HISTORIC AND DESIGN REVIEW COMMISSION

HDRC CASE NO: 2020-114
ADDRESS: 101 ARMOUR
LEGAL DESCRIPTION: NCB 6202 BLK 3 LOT 1
ZONING: R-4, H
CITY COUNCIL DIST.: 1
DISTRICT: River Road Historic District
APPLICANT: Vicki Yuan/WALLACE MATTHEW D &
OWNER: Vicki Yuan/WALLACE MATTHEW D &
TYPE OF WORK: Window replacement, fenestration modifications, exterior modifications
APPLICATION RECEIVED: February 28, 2020
60-DAY REVIEW: April 30, 2020
CASE MANAGER: Rachel Rettaliata

REQUEST:

EAST ELEVATION - WEST WING

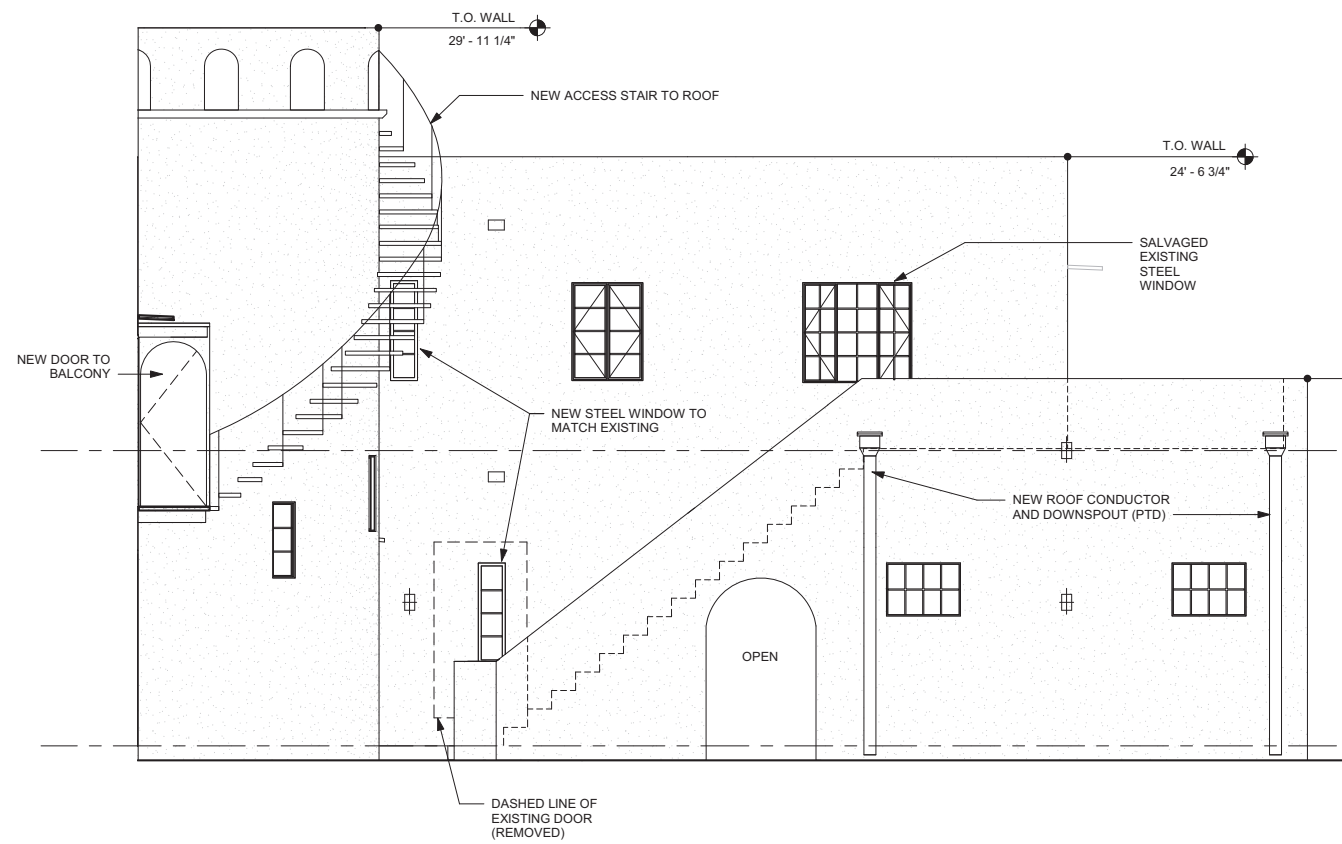
- i. FENESTRATION MODIFICATION: EAST ELEVATION, WEST WING – The applicant has proposed to remove the existing steel-framed double doors with stained glass (1.5) and install a new steel casement window to match the existing windows on the tower. As the opening currently opens onto existing exterior stairs and does not feature a safe egress, staff finds the proposal consistent with the Guidelines.

FIRST FLOOR EXISTING WINDOW AND DOOR CONDITIONS

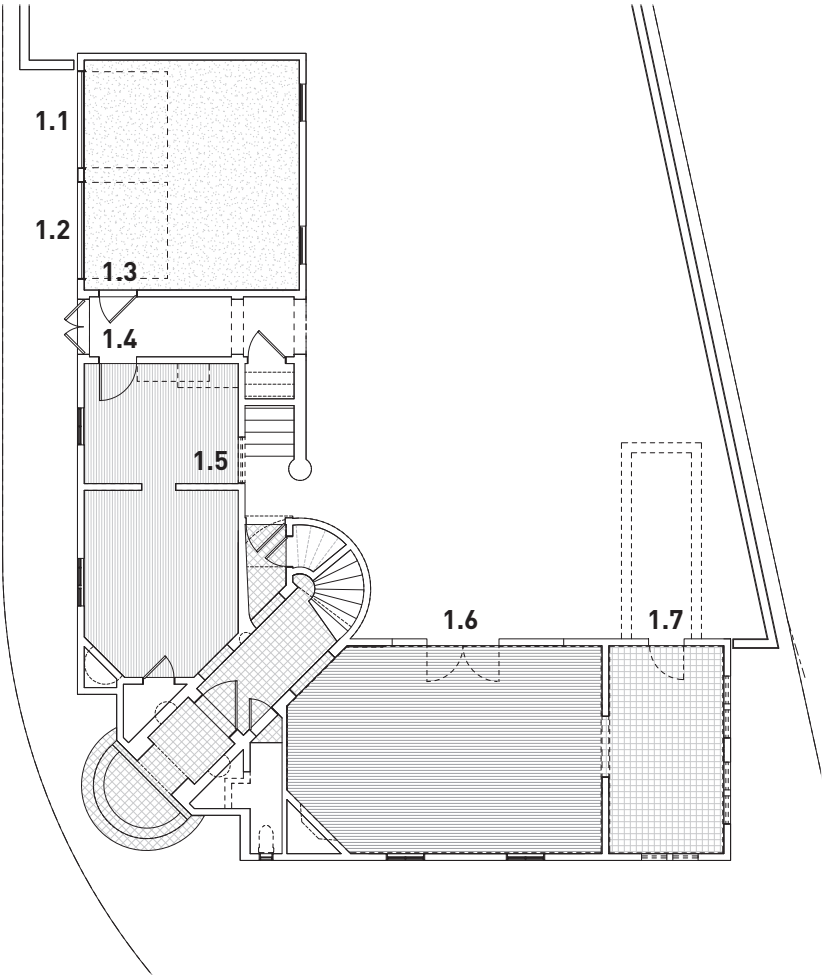
- g. DOOR REPLACEMENT – The applicant has proposed to replace the existing painted aluminum garage doors (1.1 & 1.2) with new wood garage doors. The aluminum garage doors are not original to the structure. Staff finds the proposal consistent with the Guidelines. The applicant has additionally requested to replace the existing wood Dutch door on the exterior of the garage (1.3) and the solid wood door on the exterior of the kitchen (1.4) with new wood doors. Staff finds the proposal generally appropriate. The applicant has also requested to replace the double wood doors with divided lite (1.6) on the north elevation with new wood doors with divided lite and screen doors to match existing. Staff finds the proposal consistent with the Guidelines. The applicant has proposed to replace the existing divided lite wood door currently opening into the aviary (1.7) with an arched wood door with divided lite to match the historic arched opening. Staff finds the proposal consistent with the Guidelines.

- h. FENESTRATION MODIFICATION: BREEZEWAY – The applicant has proposed to relocate the current door opening on the exterior of the kitchen in the breezeway (1.4) to be more centered in the interior space. As the door opening is within a breezeway between the garage and the west wing and is not visible from the public right-of-way, staff finds the proposal generally appropriate.

SECOND FLOOR EXISTING WINDOW AND DOOR CONDITIONS

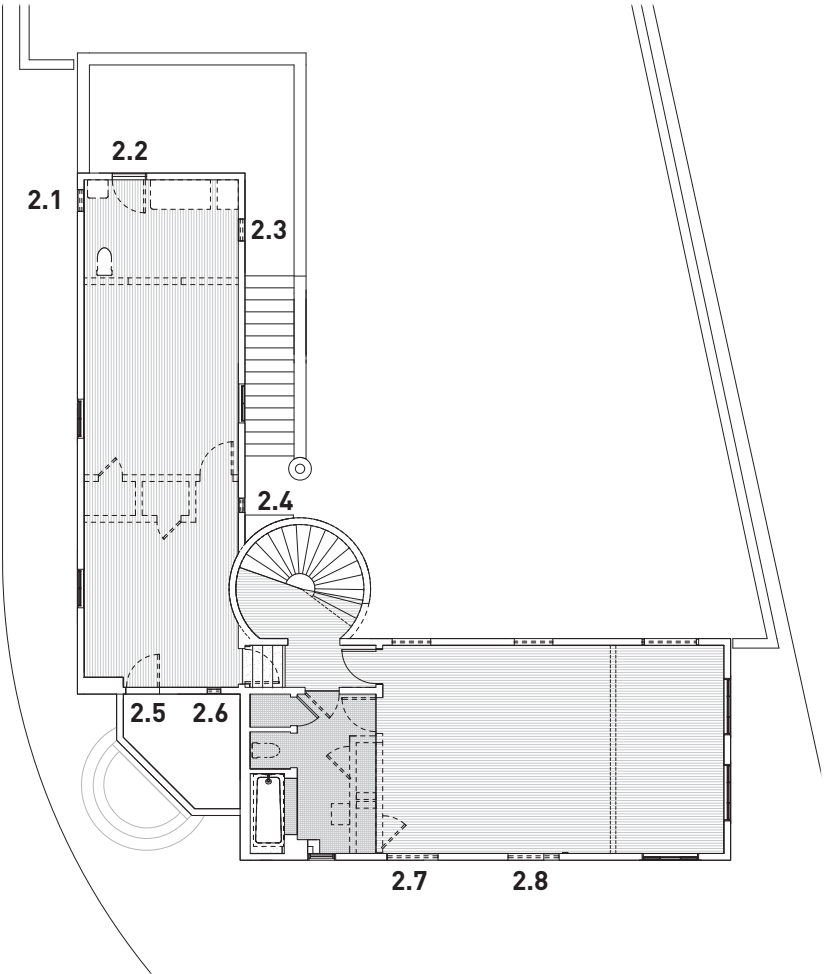
- c. WINDOW REPLACEMENT: ONE-OVER-ONE WOOD WINDOWS – The applicant has proposed to remove the existing one-over-one wood windows (2.1 & 2.3) in the second-floor bathroom on the west and east elevations and replace the windows with existing steel casement windows that will be salvaged from the second floor of the north elevation. The west wing of the structure was originally one story and the second story was constructed as an addition circa 1950; therefore, the existing wood windows and openings are not original to the structure. Staff finds the proposal consistent with the Guidelines.

- d. WINDOW REPLACEMENT: WOOD CASEMENT WINDOWS – The applicant has proposed to remove the existing wood casement windows (2.4 & 2.6) from the second floor. The existing wood casement windows are missing all glass panes and hardware and do not close. The applicant has proposed to replace windows 2.4 and 2.6 with new steel casement windows to match the existing in size and profile. Guideline 6.B.iv for Exterior Maintenance and Alterations states that new windows should match the existing windows in terms of size, type, configuration, material, form, appearance, and detail when original windows are deteriorated beyond repair. However, staff finds that steel casement windows are appropriate for the style and age of this structure.

- k. FENESTRATION MODIFICATION: SOUTHWEST CORNER BALCONY – The applicant has proposed to replace the existing full lite wood door on the second-floor corner balcony with divided lite French doors to match the doors proposed elsewhere on the structure. Although opening 2.5 is on the primary façade and is visible from the public right-of-way, staff finds the proposed replacement door to be more in keeping with the architectural character of the structure. Staff finds the proposal appropriate.

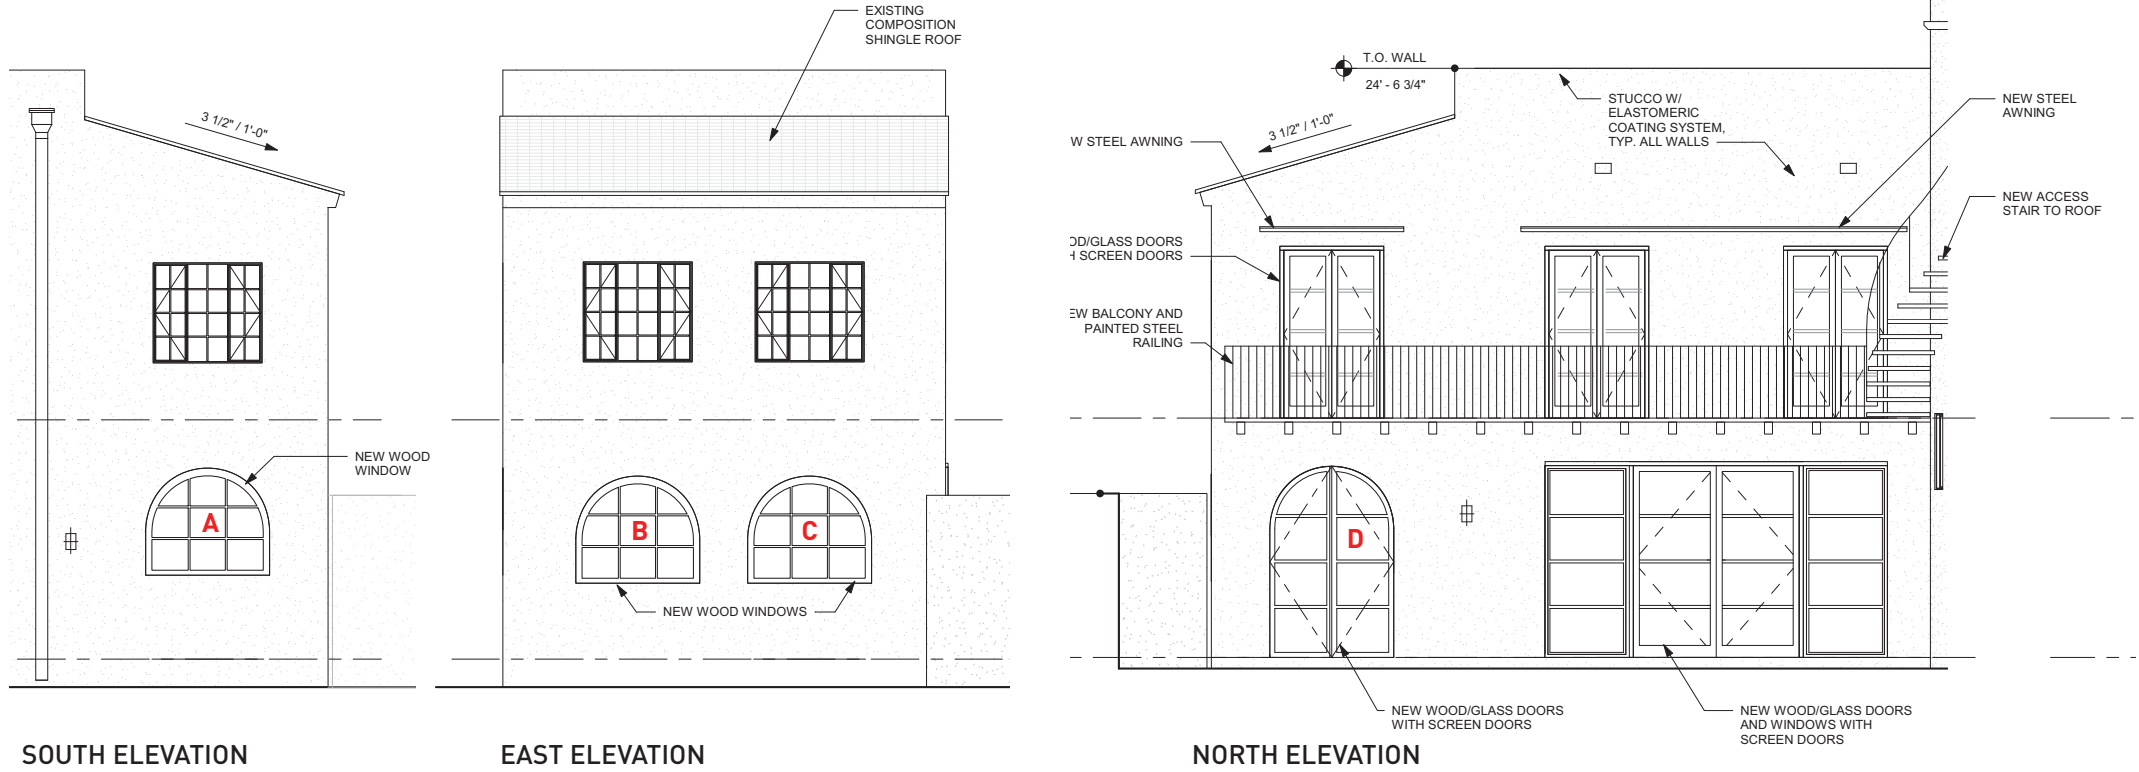
- e. WINDOW REPLACEMENT: ONE-OVER-ONE WOOD CASEMENT WINDOWS – The applicant has proposed to replace the existing one-over-one wood casement windows on the second floor of the south elevation (2.7 & 2.8) with new wood casement windows to match the existing. The existing wood windows are

- f. WINDOW REPLACEMENT: VINYL WINDOWS – The applicant has proposed to remove the existing vinyl windows on the first floor of the south and east elevations (A, B, and C) with new arched wood windows to match the historic window openings as shown in historic photos of the interior and exterior. Staff finds the proposal consistent with the Guidelines.

NORTH ELEVATION - EAST WING

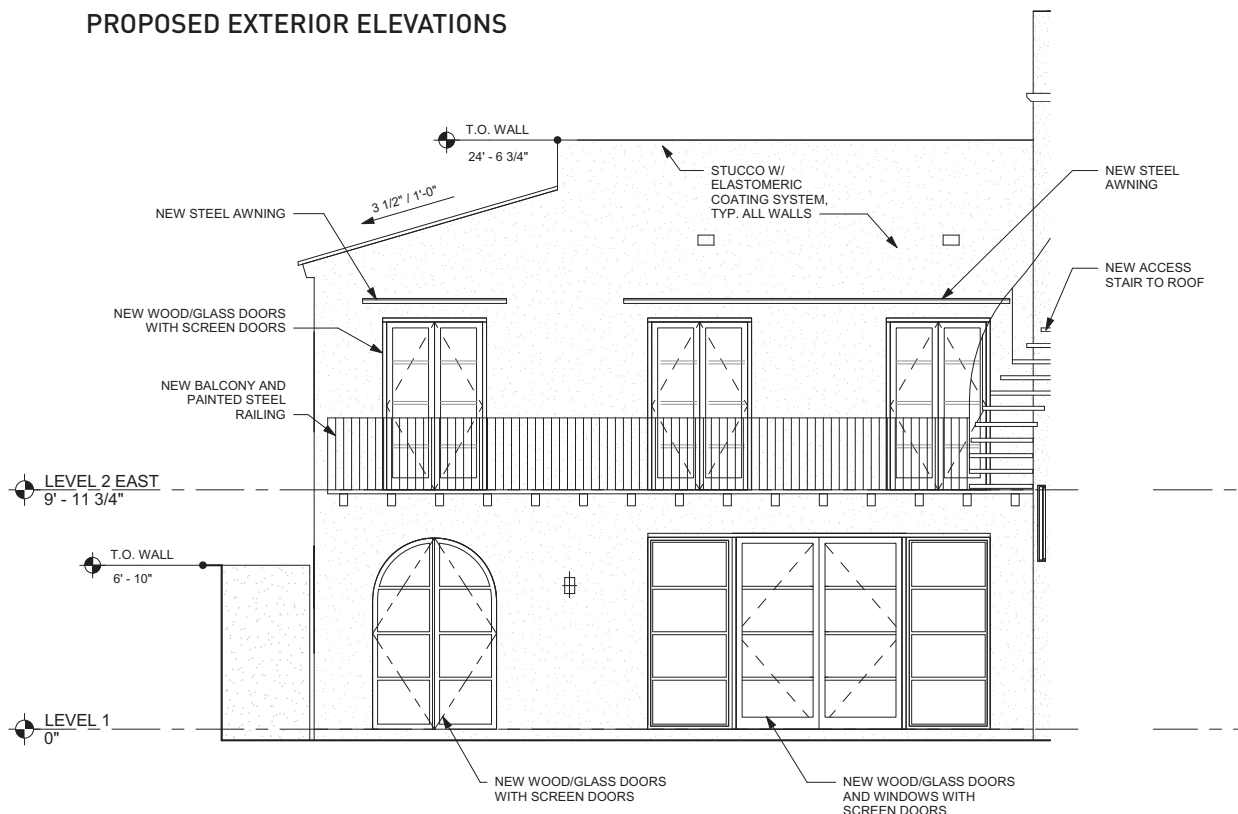
- l. FENESTRATION MODIFICATION: NORTH ELEVATION, EAST WING – The applicant has proposed to remove the three divided lite steel windows from the second-floor north elevation of the east wing. The applicant has proposed to salvage the steel windows to be used as replacement windows elsewhere on the structure. The applicant has proposed to replace the steel windows with divided lite wood French doors with screens. The replacement doors will open onto a proposed second-floor balcony. As the north elevation of the east wing is not visible from the public right-of-way, staff finds the proposal appropriate.

- n. BALCONY INSTALLATION – The applicant has proposed to install a new second-floor balcony with a painted steel railing on the north elevation of the east wing. The proposed balcony will not be visible from the public right-of-way and the condition is reversible. Guideline 7.A.i for Exterior Maintenance and Alterations stipulates that applicants should not add new porches, balconies, or porte-cochères where not historically present. However, as the north elevation of the east wing is not visible from the public right-of-way, staff finds the proposal appropriate.

- o. AWNING INSTALLATION – The applicant has proposed to install steel awnings above the proposed doors on the second floor of the north elevation on the east wing, above the proposed doors on the second floor of the north elevation on the west wing, and above the proposed French doors on the second floor of the southwest corner elevation. Staff finds that the installation of the awnings is reversible and appropriate.

NORTH ELEVATION - WEST WING

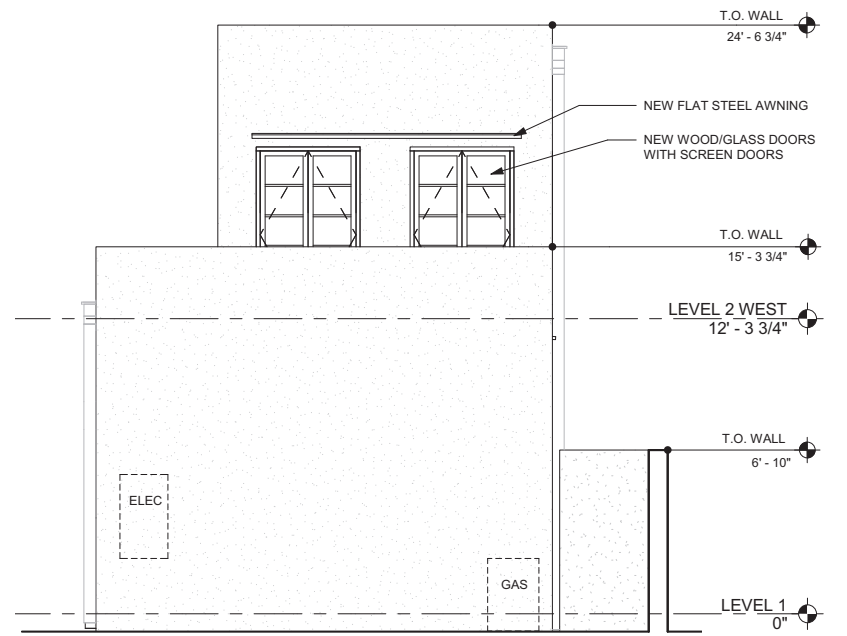
- j. FENESTRATION MODIFICATION: NORTH ELEVATION, WEST WING – The applicant has proposed to replace the existing full lite wood door on the second floor of the north elevation of the west wing (2.2) with new wood double doors with divided lite and screen doors and create a new opening beside opening 2.2 to install a matching set of doors. The two sets of doors will serve as egress for the roof terrace. As the second floor of the west wing is not original to the structure, staff finds the proposal consistent with the Guidelines.
